## **Access Compliance Report Public Rights-of-Way** (Curb Ramps)

Intersection ID: 11408 Main Street: N\_SMITH\_ST Cross Street: W\_8TH\_ST Location:

**Overall Compliance: No ADA ID: 8FE46CE9101D** Ramp Type: BlendTrans2 Initial Pass/Fail: Pass **Severity Score:** 17.5

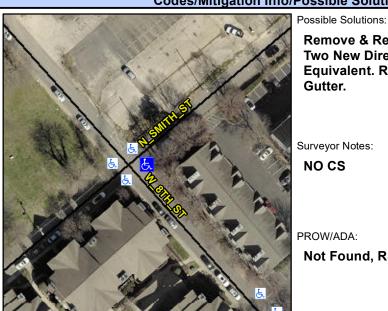
Street 1 Name Stop Condition-Street 1 Street 2 Name Stop Condition-Street 2 **N SMITH ST** None W 8TH ST StopSign Remove & Replace Curb Ramp With Two New Directional Ramps or Equivalent. Remove & Replace Gutter.

NO CS

Not Found, R305, R302.7.2, R304.5.3
